Sydney Metro City & Southwest Chatswood to Sydenham Environmental Impact Statement Objection and proposal for the consideration of added inner-city stations.	1
Background to this objection	3
Recently announced projects	3
Population growth and transport modelling	3
Westconnex and traffic modelling	4
Value Creation and preservation of health and amenity	5
Inadequate public consultation	5
Revision of station locations (Additional Metro stations)	5
Conclusion	6
Section 2: Proposal for additional station options	7
Option 1. Alexandria Metro Station	7
Option 2. Alexandria station and McEvoy OR St Peters	15
Option 3. Alexandria station and McEvoy and St Peters stations	18
Summary	18
References:	20

Sydney Metro City & Southwest Chatswood to Sydenham Environmental Impact Statement Objection and proposal for the consideration of added inner-city stations.

Figure 2: Phase 1 did not identify viable station located on the 'mid-point' of the Waterloo - Sydenham alignment

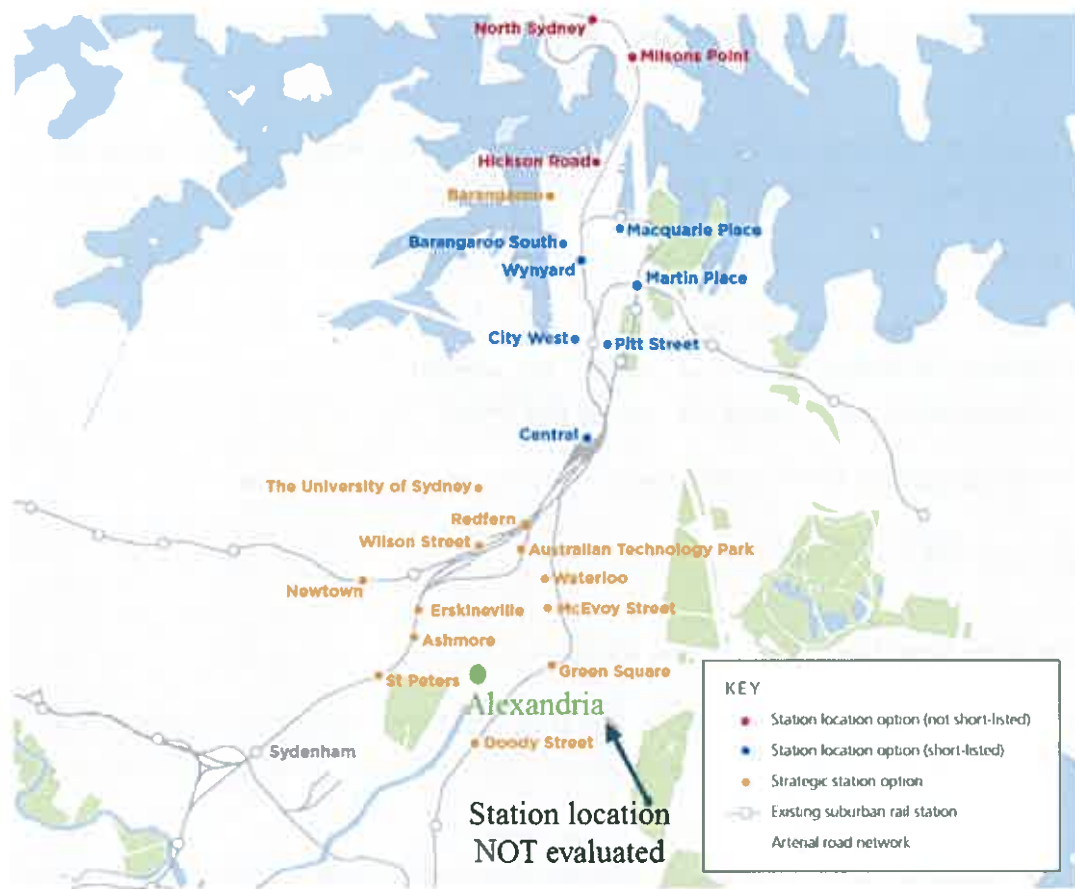
The Phase 1 station location phase failed to identify a viable Alexandria station at the approximate 'mid-point' of the Waterloo alignment (see Figure 1). This submission proposes and evidences why the provision of an additional station (Alexandria) is a minimal response to better provisioned and better integrated transport systems in the inner-city.

Figure 3: Metro Alignment Options

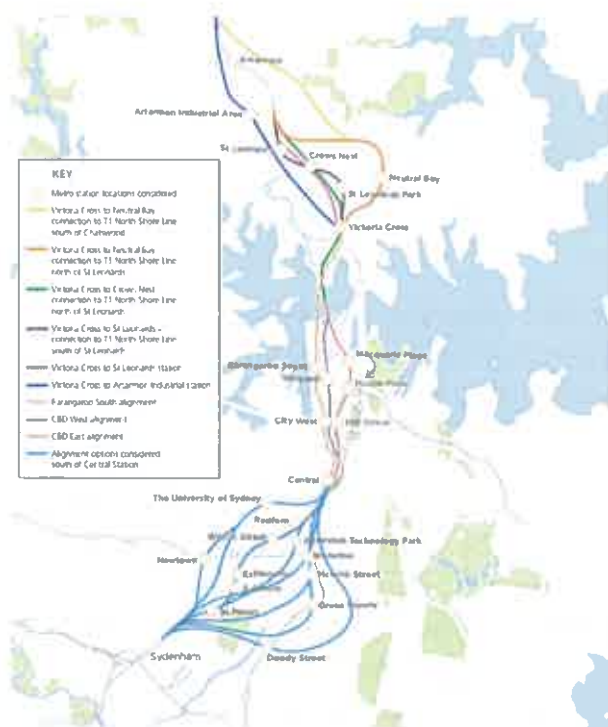
This option provides 1 additional Metro station at an approximate mid-point between Waterloo and Sydenham. Performance of this new station location against Metro project Objectives is provided in this section.

Note: This station location is NOT the same as the determinations made on an Ashmore station location, which was situated closer to Erskineville station. It therefore cannot be judged on the outcomes of the Ashmore station performance. In addition, this station location was NOT evaluated on the Metro Alignment Options (See Figures 2 and 3).

Figure 4: Alexandria Metro Station location and catchment area, (Numbers indicate known near-term population and student growth)

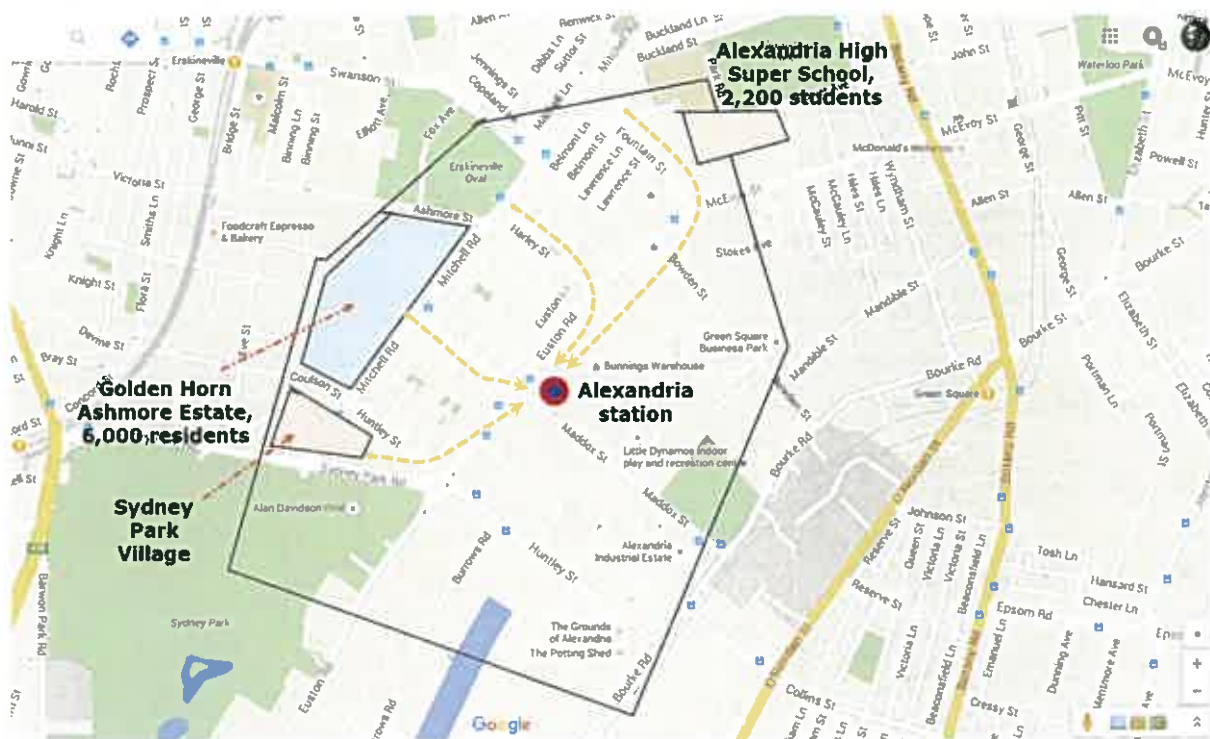
network resilience as described below. It is situated at an approximate mid-point on the 4 kilometre 'station gap' between Waterloo and St Peters. Figure 5 shows the proposed Alexandria station location and catchment area.

This station option would provide immediate high capacity patronage from the Ashmore Estate / Alexandria growth area. It would improve other train line experiences by drawing peak hour overcrowding off Erskineville station, and positively impact on overall transport network resilience (through traffic reduction). It would provide city wide interconnectivity via current bus route connections and a 10 minute walk to the Green Square / Airport rail corridor.

Figure 11: Station option performance (Metro documentation)

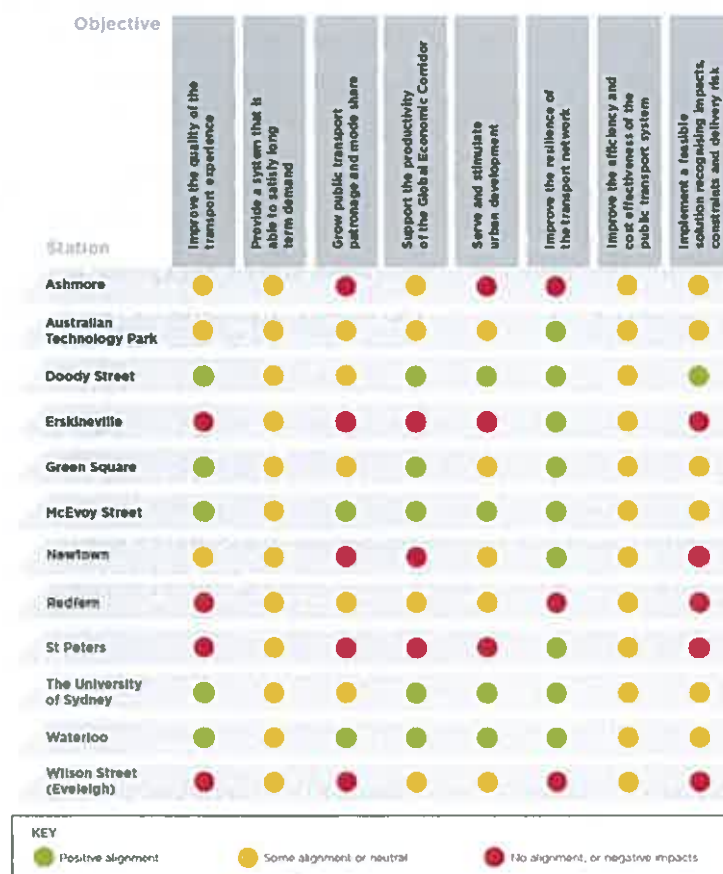
This station location could grow total network capacity by integrating to a bus interchange / increased bus routes as part of a district transport plan. While St Peters was considered to be negatively aligned for urban development, low-medium density development could be possible on this site.

At minimum, serious consideration should be given to boring out a station plate at St Peters to provide for a future station fit-out. This provides transport planning agility and an 'insurance policy' type approach to expand network interconnectivity on this strategic north- south / east – west transport corridor. This provides a 'safety-net' to rapidly increase the transport network capacity if the road network reaches saturation and mass transit systems require fast activation.

Table 7-11 Blues Point temporary site indicative construction program

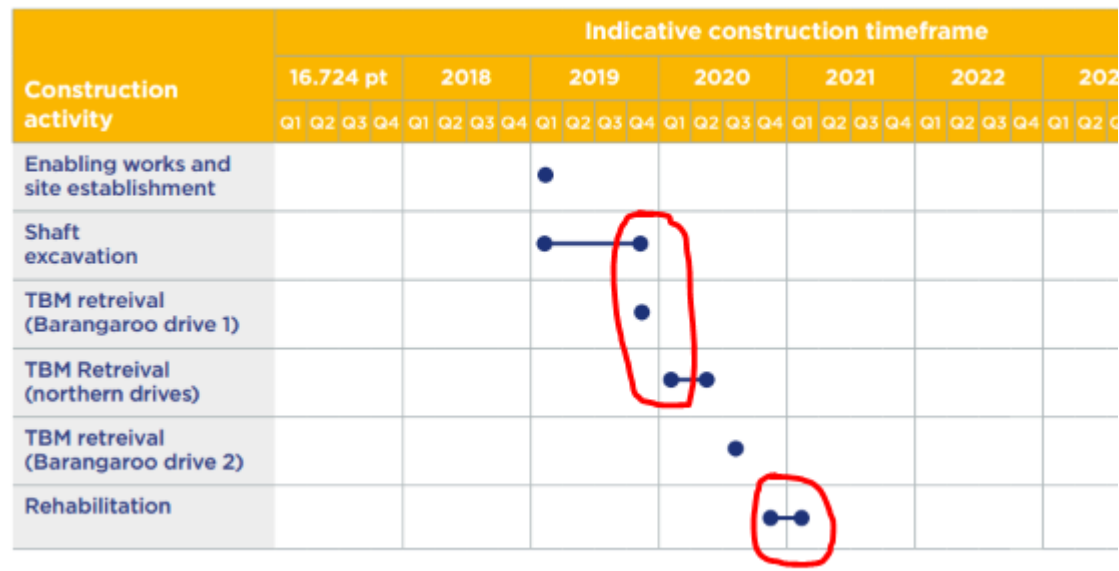
Objection to the plan to rehabilitate from Q4 2020 through to Q1 2021 thereby impacting 2 years of NYE

Every New Years Eve, thousands of visitors flock to Blues Point Reserve to watch the fireworks. The reserve is one of the best places in Sydney to watch the iconic event. .

As the snip from Page 220 of the EIS shows, Blues Point Reserve will be mostly unusable for NYE celebrations on NYE2020 and NYE2021. If the park is to be used for this project, greater efforts need to be made in the planning to bring forward proposed rehabilitation and limit the impact to NYE to just NYE2020.

Figure 3: Metro Alignment Options

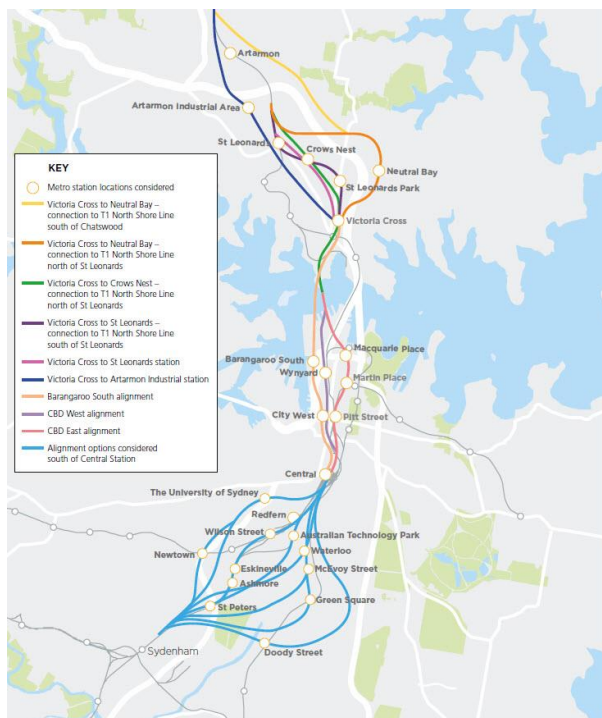
This option provides 1 additional Metro station at an approximate mid-point between Waterloo and Sydenham. Performance of this new station location against Metro project Objectives is provided in this section.

Note: This station location is NOT the same as the determinations made on an Ashmore station location, which was situated closer to Erskineville station. It therefore cannot be judged on the outcomes of the Ashmore station performance. In addition, this station location was NOT evaluated on the Metro Alignment Options (See Figures 2 and 3).

Figure 4: Alexandria Metro Station location and catchment area, (Numbers indicate known near-term population and student growth)

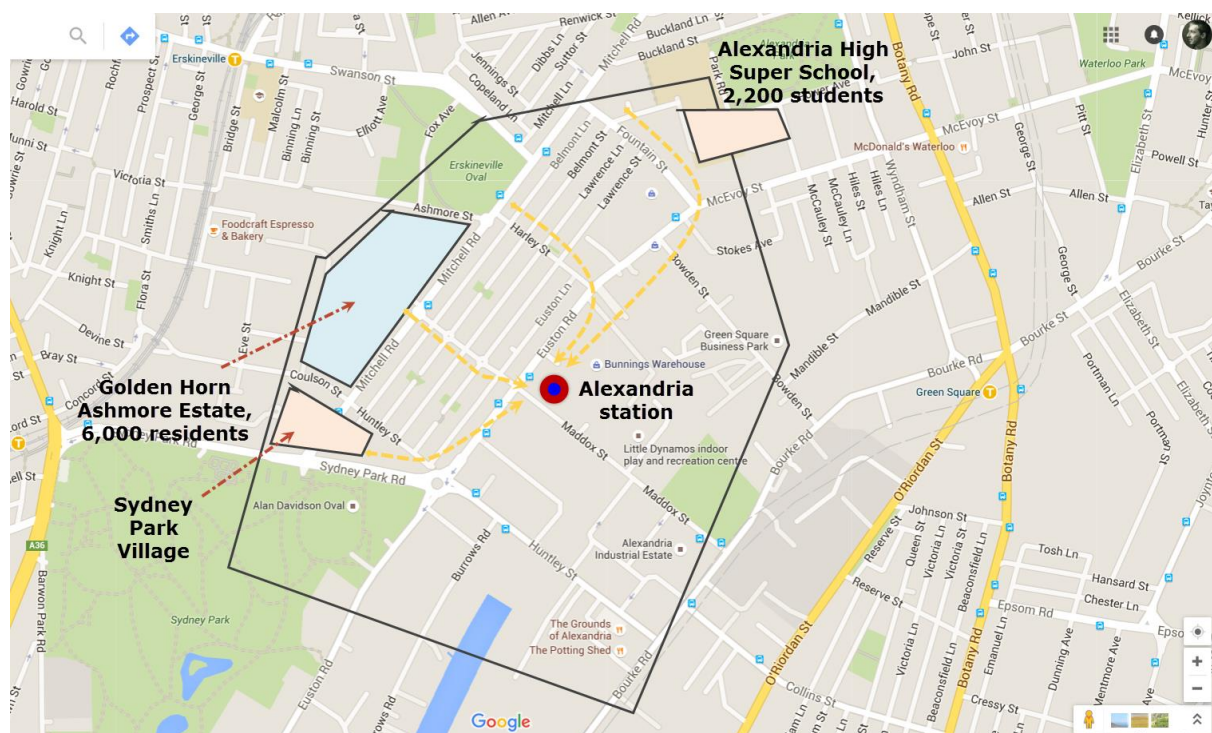
network resilience as described below. It is situated at an approximate mid-point on the 4 kilometre 'station gap' between Waterloo and St Peters. Figure 5 shows the proposed Alexandria station location and catchment area.

This station option would provide immediate high capacity patronage from the Ashmore Estate / Alexandria growth area. It would improve other train line experiences by drawing peak hour overcrowding off Erskineville station, and positively impact on overall transport network resilience (through traffic reduction). It would provide city wide interconnectivity via current bus route connections and a 10 minute walk to the Green Square / Airport rail corridor.

Figure 8: Proximity of Westconnex to approved Metro alignment and proposed Alexandria station

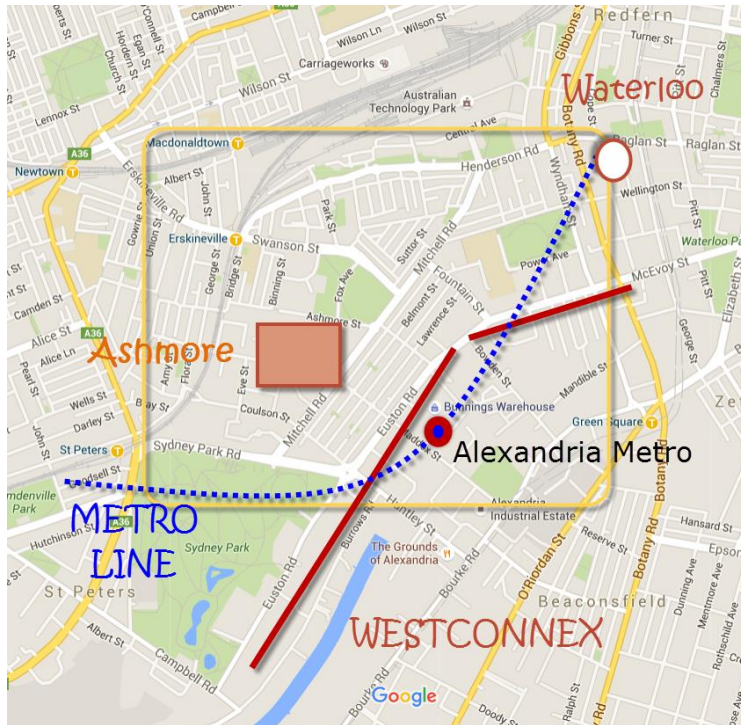
Extensive provisioning of public transport through the inner-city will take cars off the road. This has tremendous benefits for local amenity, car and bus trip times, pollution and greenhouse reduction and the preservation of health and amenity. It benefits the wider city as Alexandria has been chosen as the 'through point' to connect the western suburbs with the east and airport corridor as part of Westconnex (Figure 8).

The Metro and Westconnex Projects intersect near Euston Road, Alexandria. The Westconnex Project EIS states that the daily load of Euston Road is predicted to increase from 7,000 cars daily to 60,000 + cars daily. As this increased traffic proceeds north-east it is expected to 'disperse' onto local roads.

Figure 11: Station option performance (Metro documentation)

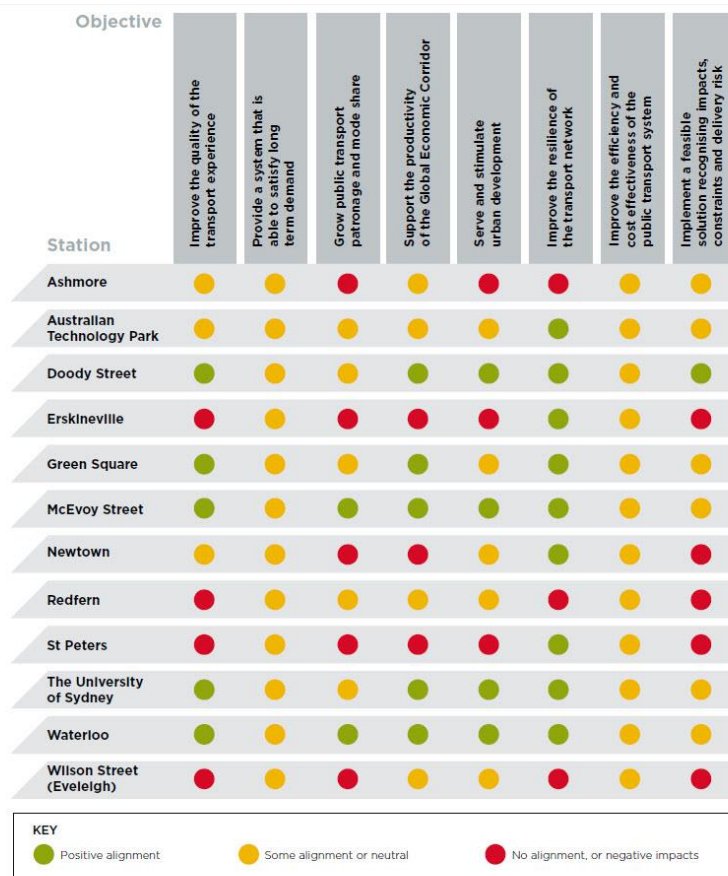
At minimum, serious consideration should be given to boring out a station plate at St Peters to provide for a future station fit-out. This provides transport planning agility and an 'insurance policy' type approach to expand network interconnectivity on this strategic north-south / east – west transport corridor. This provides a 'safety-net' to rapidly increase the transport network capacity if the road network reaches saturation and mass transit systems require fast activation.

Figure 1. Location of subject sites in relation to the proposed tunnel alignment and corridor.

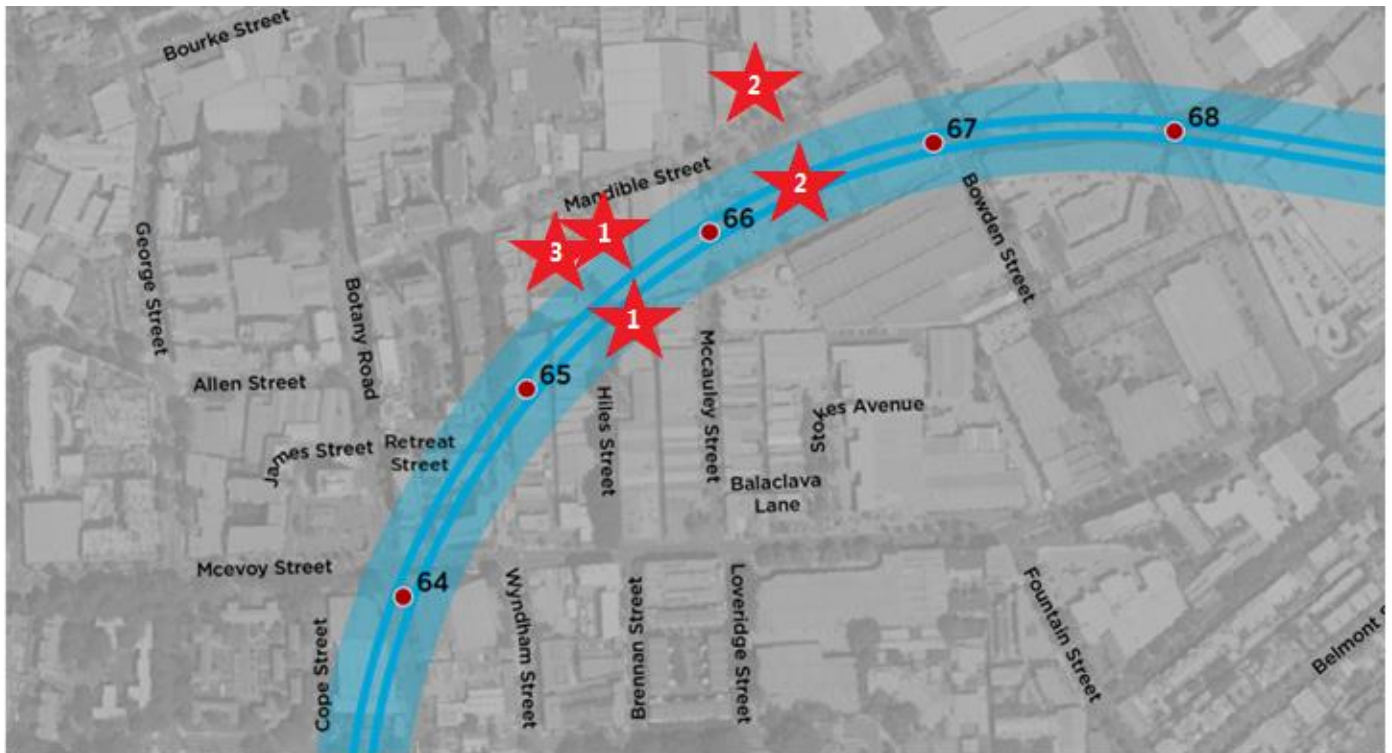
We note that our clients' offer their in principle support to the overall Sydney Metro project and the new rail station at Waterloo in particular. However, according to the EIS the subject sites' will be directly impacted by the project via the underground alignment of the tunnel between Waterloo Station and Sydenham Station. The location of the subject sites in relation to the underground tunnel alignment is illustrated in Figure 1 below.

Accordingly they wish to lodge their objection to the proposal as currently exhibited for the following reasons:

Request for Proponent to Realign Tunnel

Figure 2. Extract from City of Sydney's *Guideline to Preparing Site Specific Planning Proposal Requests in the City of Sydney Employment Lands Investigation Areas 2015*

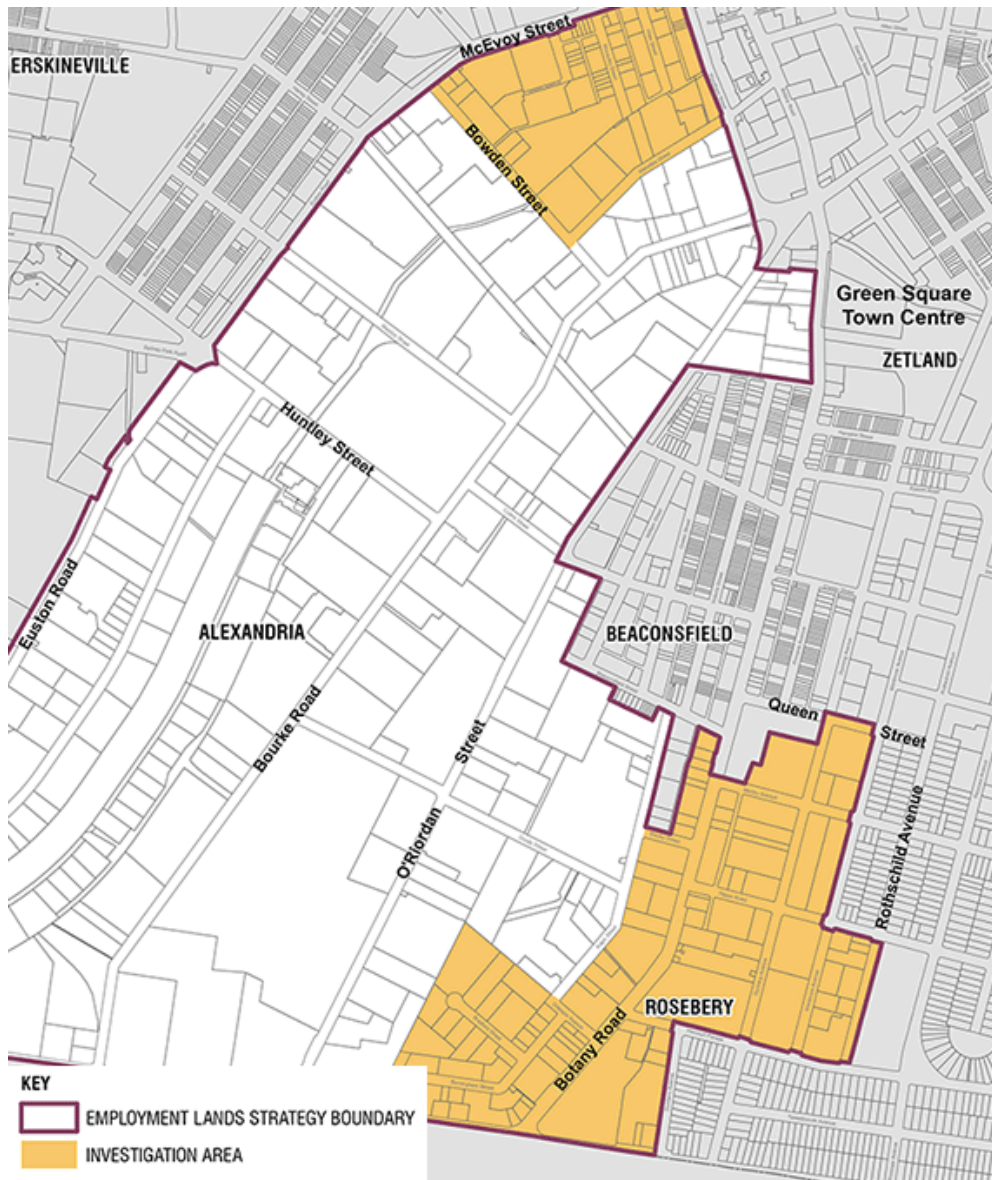
3. The subject sites are located within the southern employment lands in the City of Sydney (the City) Local Government Area (LGA). These sites are also in an area the City has identified as "investigation areas". Refer Figure 2.

There is also no proposed mitigation to limit any such impacts, nor adequate compensatory measures to account for any reduction in future development potential.

This lack of information is considered a serious omission from a document that purports to determine environmental impacts upon existing and future land use. Further clarification of these likely constraints and impact on development potential is requested to be made available for further comment prior to the finalisation and endorsement of the EIS.
